**STAFF REPORT
SPECIAL CERTIFICATE OF APPROPRIATENESS
FOR THE PROPERTY AT
1137 OBISPO AVENUE
A CONTRIBUTING RESOURCE WITHIN
THE “OBISPO AVENUE HISTORIC DISTRICT”**

Proposal: The application requests design approval for an addition and construction of a new carport, alterations to the residence and sitework. Variances have also been requested from Article 2, Section 2-101 D (4) b. i. of the Coral Gables Zoning Code for the minimum east and west side setbacks of the addition and new carport.

Figures 5: Proposed Addition Plan | Photo Key Plan

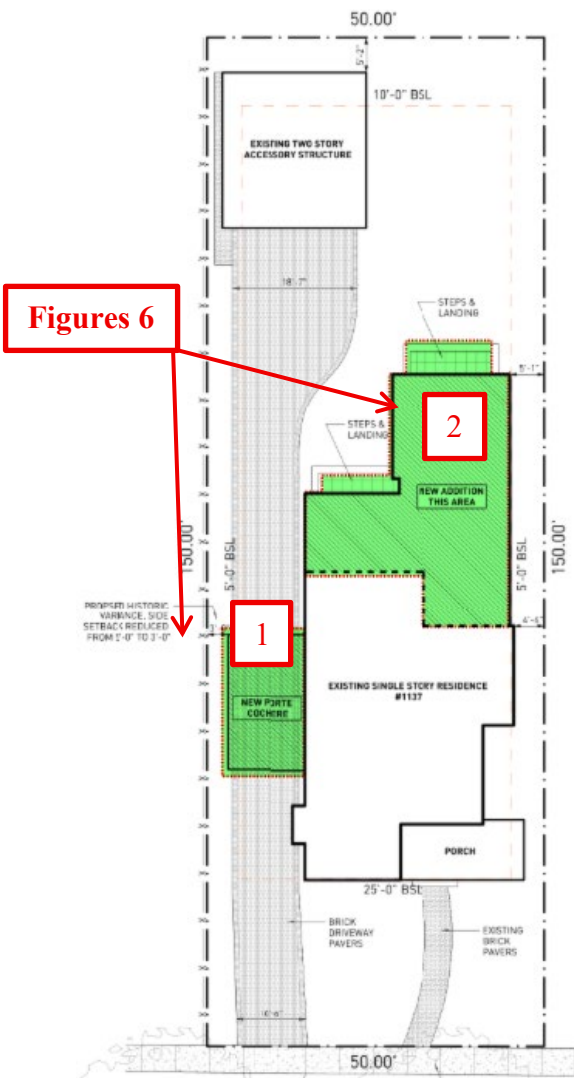
- Construction of an approximately 764 SF, one-story, rear addition with a gable roof to the main residence (Figures 4,5&6). The rear addition includes a primary bedroom, bathroom, closet and kitchen. On the East elevation there is a 6" set back to differentiate the new addition from the original structure. On the west side there is a continuous wall, staff recommends incorporating a score line where the addition starts and the original structure ends. Window and door configurations are in line with the style of the building. The BOA had recommended that the applicant consider adding windows to the addition, those comments have not been addressed but should we worked out with staff.

- The new carport is setback from the main volume of the house behind the existing chimney between existing openings. The flat roof structure sits below the eave of the original house and has arched openings on all three sides. The wing wall detail proposed should only be implemented on the front column. The carport addition is detailed in a manner that compliments the style of the house.

1. Work with staff on the final windows/doors configuration to match the 1940s photo and original drawing location and style, as best as possible.
2. Window/door muntins are to be high-profile / dimensional.
3. Window/door glass to be clear / no tint / no reflectivity / no low-e.
4. Window sills on the new addition should be removed or differentiated from the original.
5. Stucco is to be differentiated from the existing home. Staff to review a sample for approval prior to application. Note that clear separation shall be represented on the west elevation continuous wall (Figures 6&7).
6. Stucco on the original structure is to remain and not be restuccoed.
7. Roof tile is to be a true, two-piece barrel tile.

8. Work with staff to incorporate the original bracket style to the restored balcony on the garage building.
9. Wing wall detail on the carport should only be used at the front column.
10. New clay tile vents will be detailed to be differentiated from the original.

Figures 8: Original Drawings Auxiliary Building

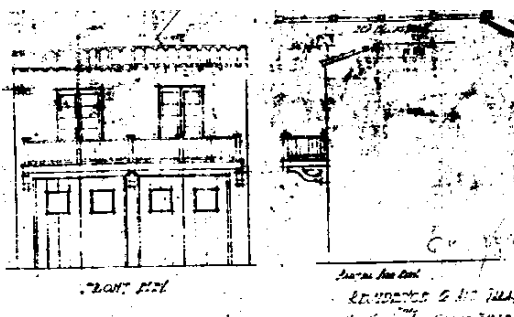
- The original auxiliary building will be restored, including the second floor balcony, French door openings and carriage style doors. The applicant should work with staff to incorporate the original bracket design to match the original plans as best as possible (Figures 8). A section of the balcony should be included in the permit set for further review.
- Sitework includes demolition of existing paving in the rear and side yard and construction of a new driveway at the side entry and rear yard (Figures 6).
